Red Hill Bulk Fuel Storage Facility, Oahu, Hawaii

September 7, 2022 Defueling Plan Supplement 1.A

Figure 1- Red Hill JP-5 Pipeline

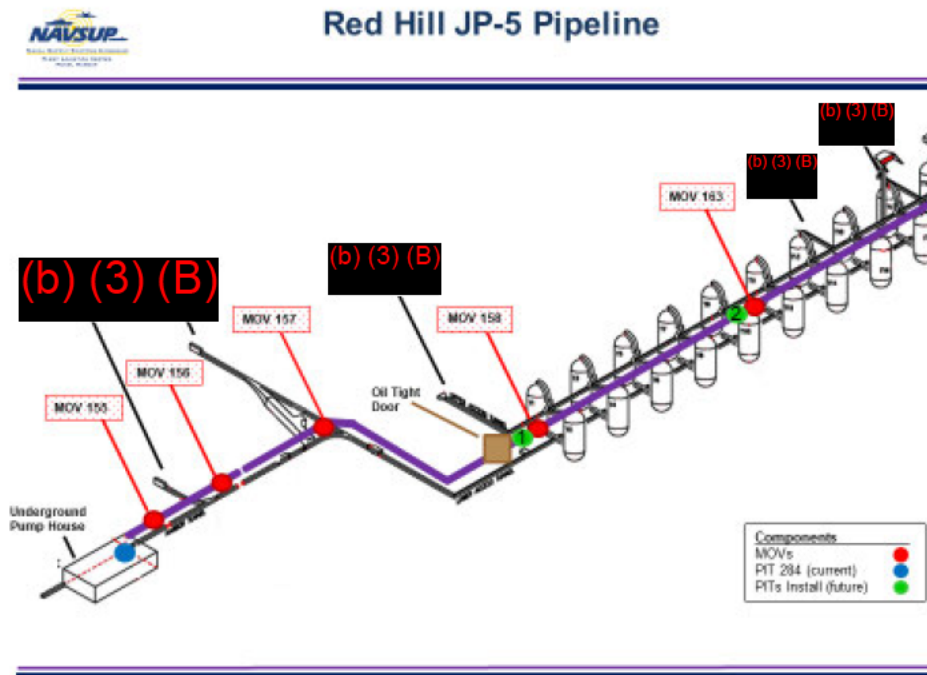
- a. Page 2 states, "All three product pipeline systems contain some fuel, and some of the infrastructure repairs (e.g., JP5 [sic] pipeline repairs, installation of Pressure Indicator Transmitters (PITs), etc.) cannot commence until those lines are unpacked." However, Page 15 states, "To enhance safety of the unpacking process, DLA is contracting for 14 additional Pressure Indicating Transmitter sensors. These sensors go into all three fuel lines to provide continuous reading of the pressure in the pipe and would allow the operators to detect in real time and address any pressure anomalies during operations." Will the unpacking*

occur to allow for the pressure indicating transmitter sensors to be installed, or can they be installed safely with fuel in the system for the purpose of unpacking for other repairs? Provide information on the planned location of these 14 PIT sensors. Confirm that the Pressure Indicator Transmitters are the same as the Pressure Indicating Transmitter sensors.

Response: The Pressure Indicator Transmitters mentioned are synonymous with Pressure Indicating Transmitters (PITs). DoD must remove fuel from the pipelines prior to installation of the PITs.

DoD plans to install two additional PITs on the F-24 pipeline in the tank gallery and three additional PITs on the JP-5 pipeline in the tank gallery. DoD plans to forego using the F-76 pipeline and will instead use the JP-5 pipeline to transfer fuel out of the tanks containing F-76. DoD will inspect the pipelines out of the two F-76 tanks to confirm that they are still in good condition before defueling them using the JP-5 pipeline.⁷ New PITs on the F-24 line will be located on the main pipeline downstream of the sectional valves near Tanks 1/2, and at the end of the line near Tanks 15/16. PITs on the JP-5 pipeline will be located on the main pipeline downstream of the sectional valves near Tanks 1/2, below the isolation valve near Tanks 10/11, and at the end of the line near Tanks 19/20. See the below schematics in figures 1 and 2.

The CPM schedule shows installation of all PITs by January 2023. DoD has amended its initial plan to install 14 PITs, reducing the number of PITs to five. It has done so for two reasons:

- 1) DoD has elected to forego repairs on the F-76 pipeline and instead use the JP-5 pipeline to transfer fuel out of the two F-76 tanks at RHBFSF. Doing so eliminates the need to make repairs on the large 32-inch diameter pipeline and eliminates the need to install PITs on that pipeline.
- 2) DoD has elected not to install PITs near the UGPH. Installing these PITs would not provide significant additional information about vacuum conditions and thus would not provide a safety benefit.
